SERVICE NO. 1449 BULLETIN

**ALTERNATE AIR CABLE CHAFE INSPECTION
AND MODIFICATION**

PA-44-180 Seminole
equipped with Fuel Injected Engines

4496404 thru 4496649

Figure 1
Alternate Air Cable Inspection Location

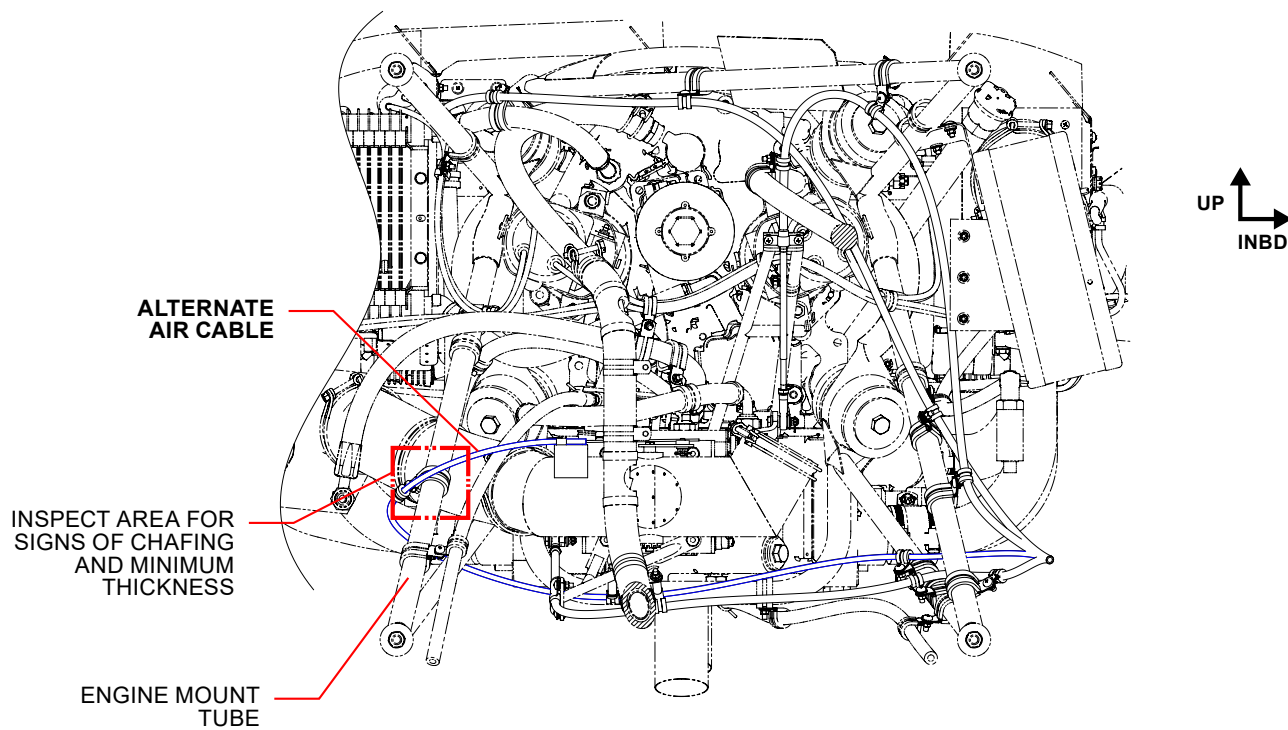
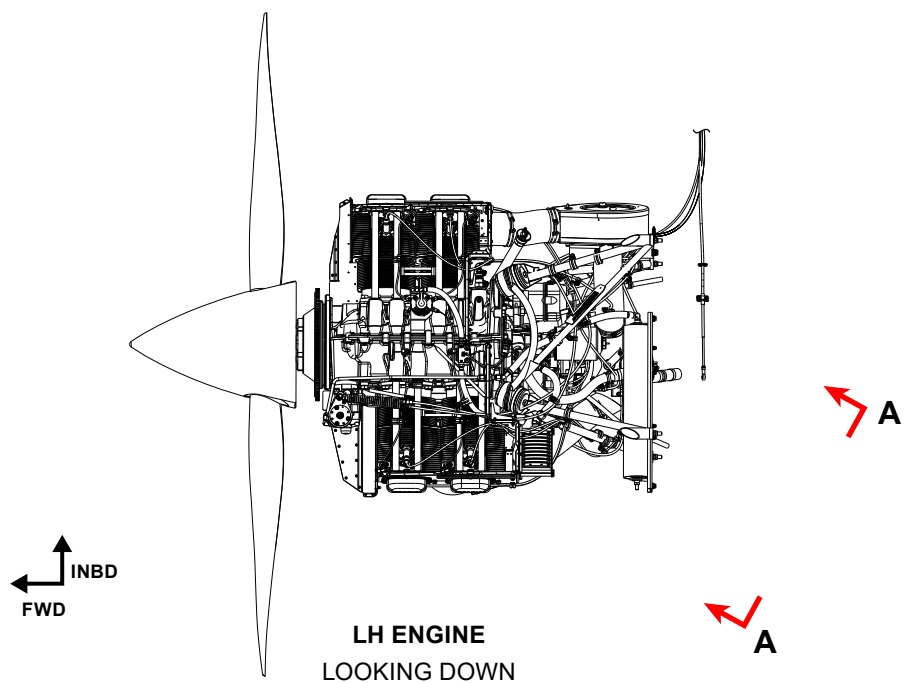
1. Locate the LH engine alternate air cable, as shown in Figure 1.
2. Remove screw, clamps, washer, and nut securing alternate air cable to the engine mount.

3. Inspect area of engine mount near alternate air cable installation for signs of chafing damage.
 - If chafing damage is found, further inspection is required. Proceed to step 4.

Figure 2 (Sheet 1 of 2)
Alternate Air Cable Installation Modification

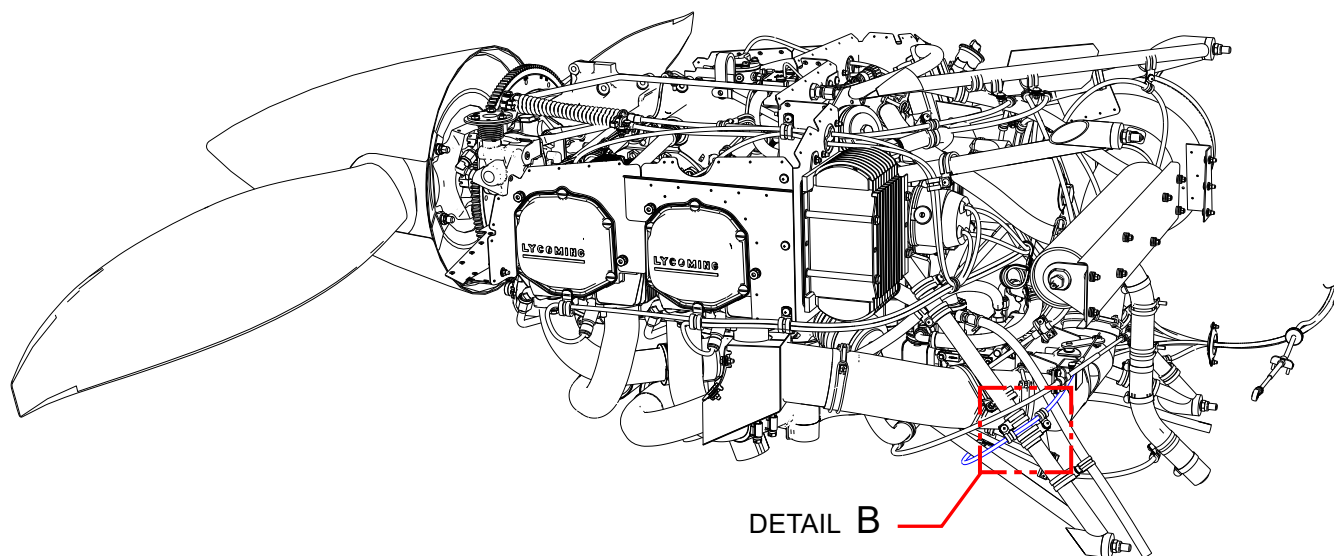
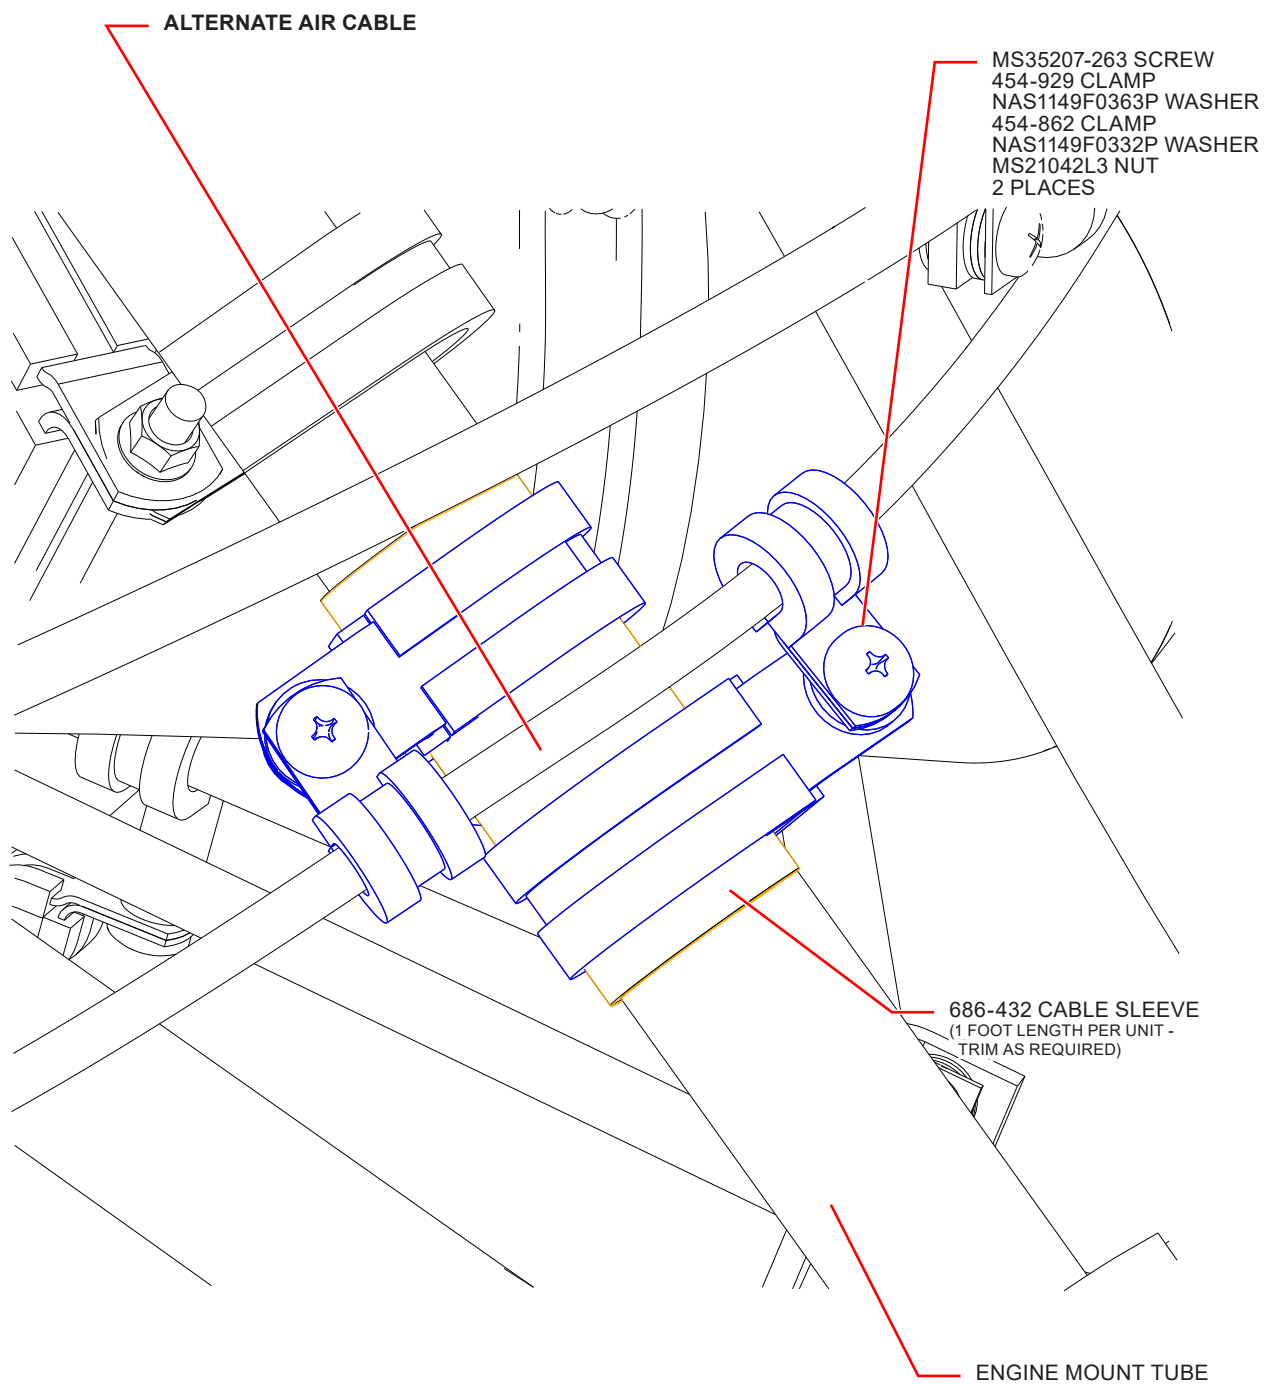
5. Regardless of whether repair/replacement of the engine mount, or no action was required, perform the necessary modifications to the alternate air cable installation, as shown in Figure 2, to mitigate future chafing damage.

- Two (2) each, Clamps, Piper P/N 454-929
- Two (2) each, Clamps, Piper P/N 454-862
- One (1) each, Cable Sleeve (1 Foot), Piper P/N 686-432

- Two (2) each, MS35207-263 Screws
- Two (2) each, NAS1149F0363P Washers
- Two (2) each, NAS1149F0332P Washers
- Two (2) each, MS21042L3 Nuts
